ADDENDUM

PROJECT TITLE: FIRE STATION #1, 5, & 7 LIGHTING RETROFIT	ADD. NO: 1
TENDER NO: 2023-082301T	DATE: March 28 th , 2023
PAGE 1 of 3 (Including Confirmation Sheet)

**CITY OF SAINT JOHN
FIRE STATIONS #1, 5 & 7
LIGHTING RETROFIT**

N.T.S. **4** E-1 **NOTES**

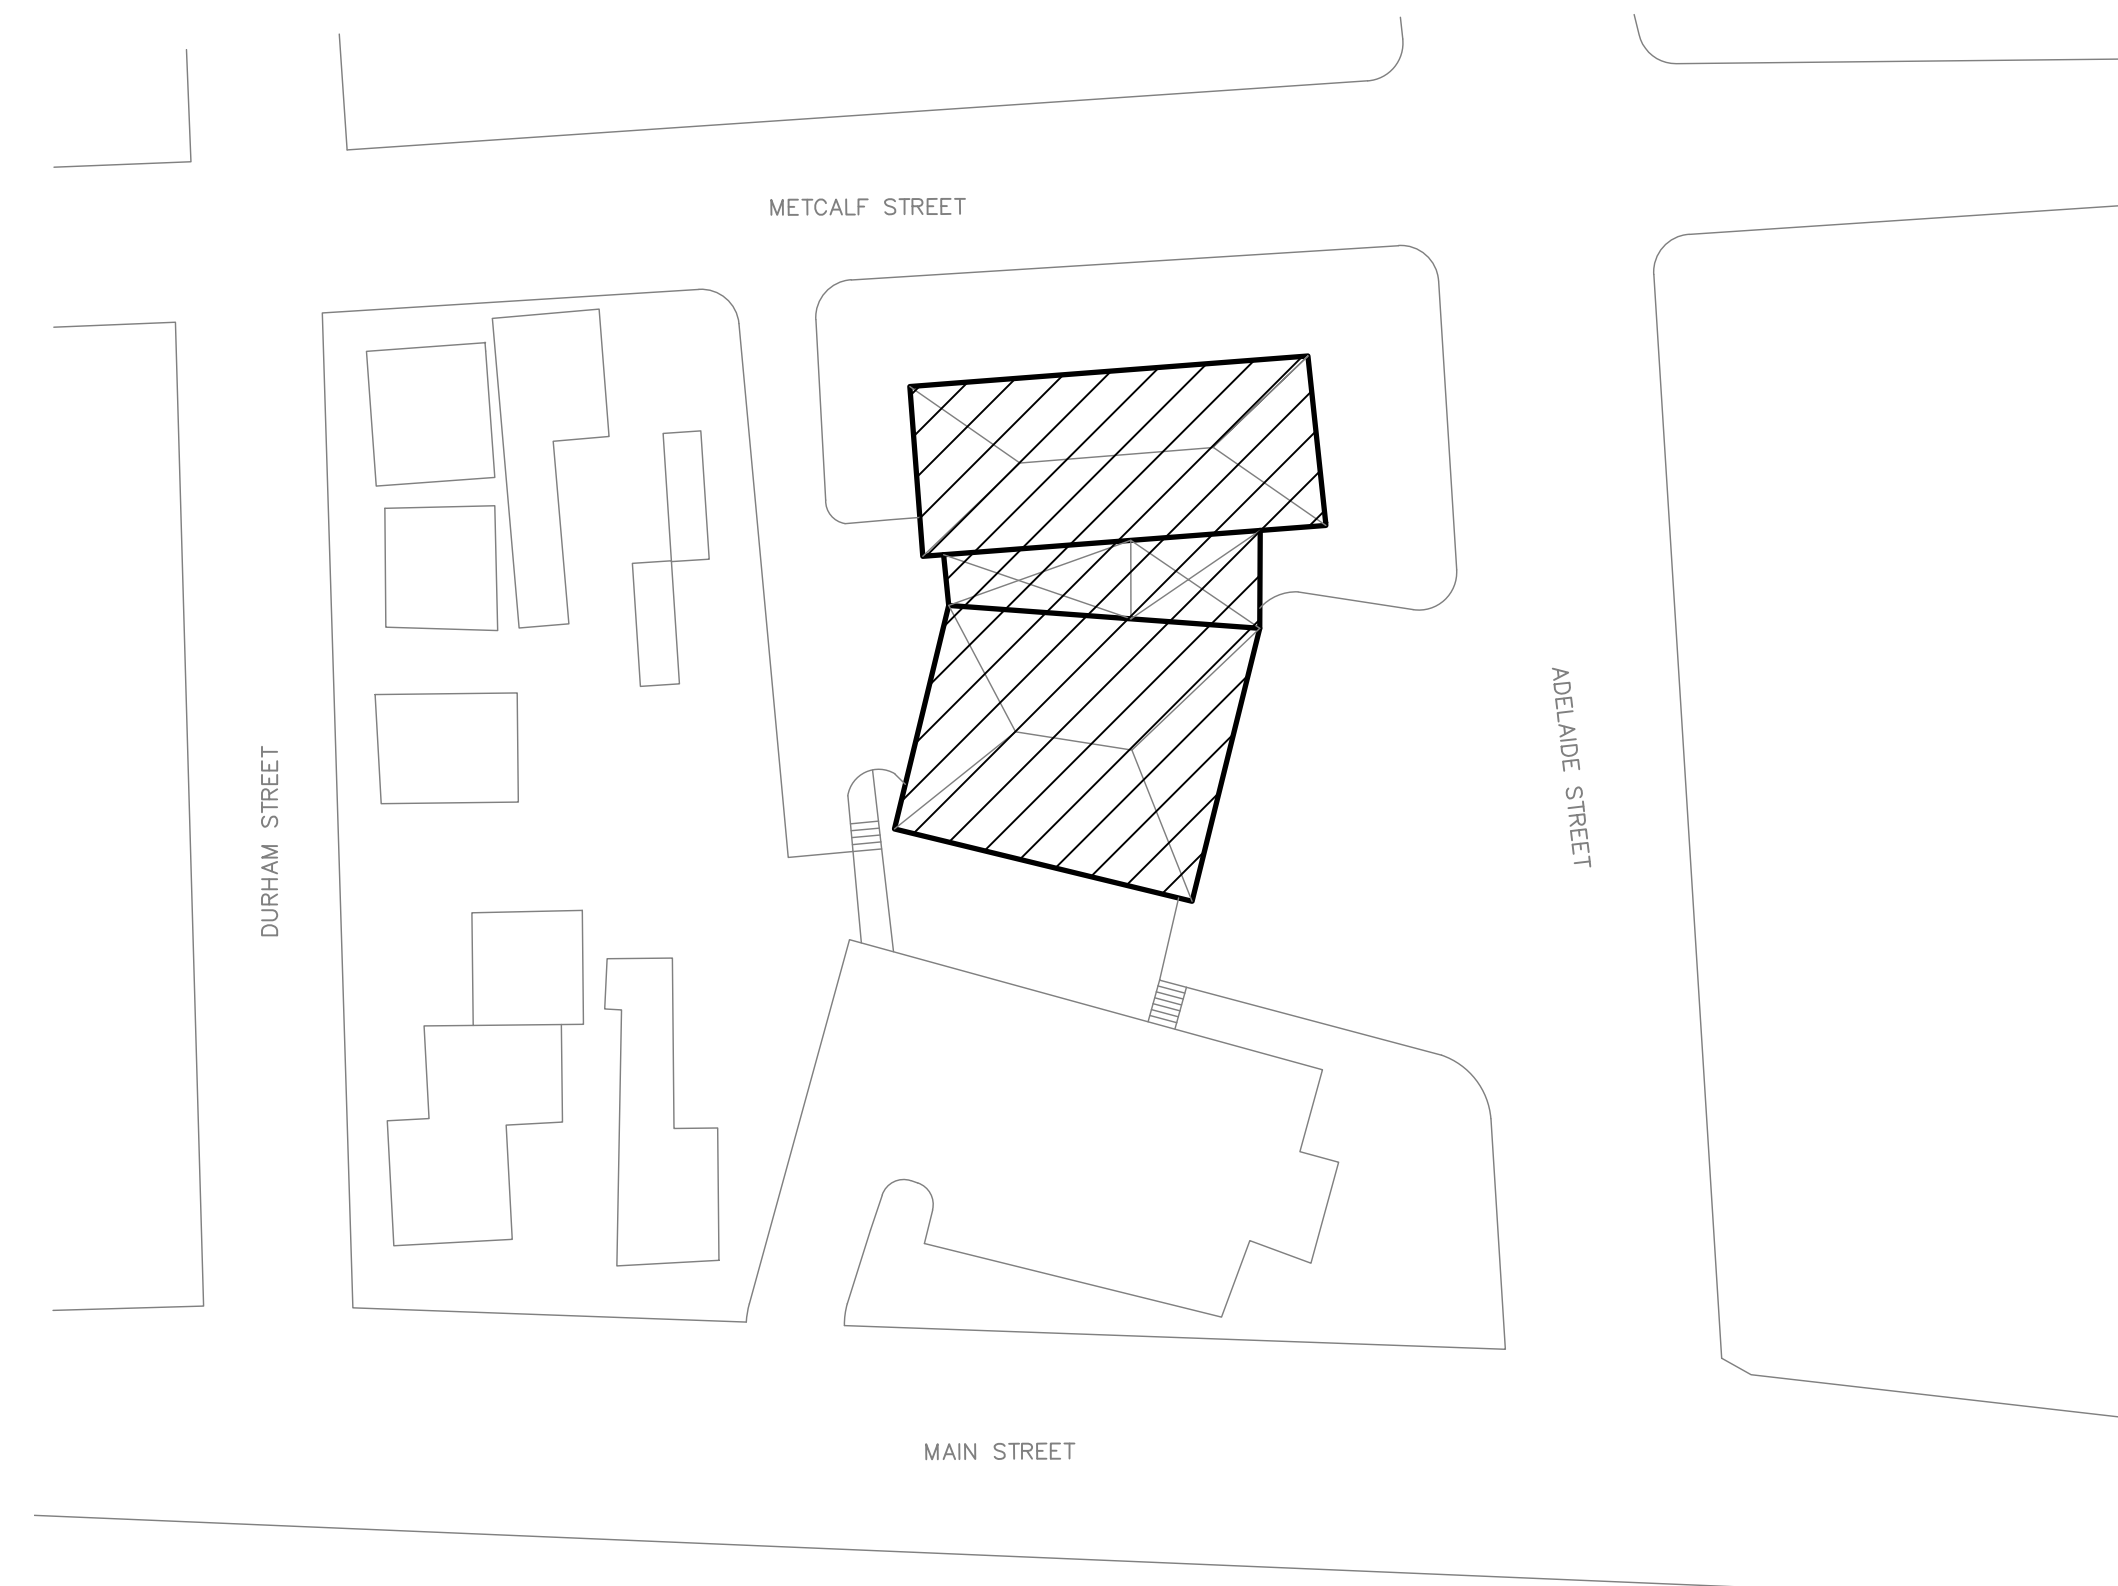
Note 2 Where does this apply? There is no detailed information provided with the tender docs. What remaining luminaires are we to re-feed? Not sure how we can price this...

Note 3 Where does this apply? There are no luminaires indicated that are fed from essential power. Not sure how we can price this...

Note 4 There are no existing switches indicated. What is required for contactors? There are no circuits indicated. Not sure how we can price this...

Note 11 What areas apply to this note? How will the bidding contractors know which areas need to be painted? Not sure how we can price this...

Note 12 Should this be confirmed by the consultant prior to specifying the new luminaires? Are the bidding contractors to measure all the existing luminaires on site Monday?

Note 14 What are the makes/model numbers of the existing luminaires? We will need this information to get pricing on the required ballast covers.

Delete Note 2: Does not apply.

Delete Note 3: Does not apply. Occupancy sensors were originally specified however have been deleted from the scope.

Delete Note 4: Does not apply.

Luminaires specified may not be the luminaires purchased, therefor contractor shall visit site to ensure the new luminaire covers the existing luminaire's footprint or paint to match, as required.

Delete Note 12: Does not apply.

Contractor shall verify the condition on site to determine if they want to clean the existing ballast cover or buy new ones. Exact size can be determined after contract has been awarded. Cost of ballast covers should not vary.

5
E-1 EXTERIOR LIGHTING CONTROLS DETAIL

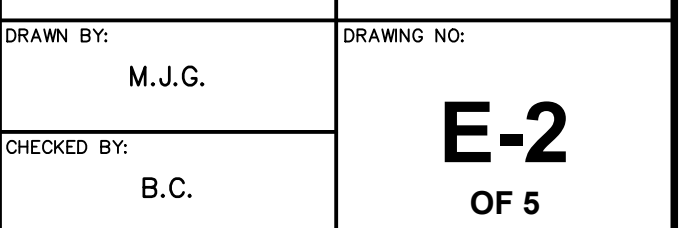
There are no exterior lighting controls indicated. Not sure how to price this...

Price the luminaires with a built-in photocell as specified, and by-pass the sensor if not required.
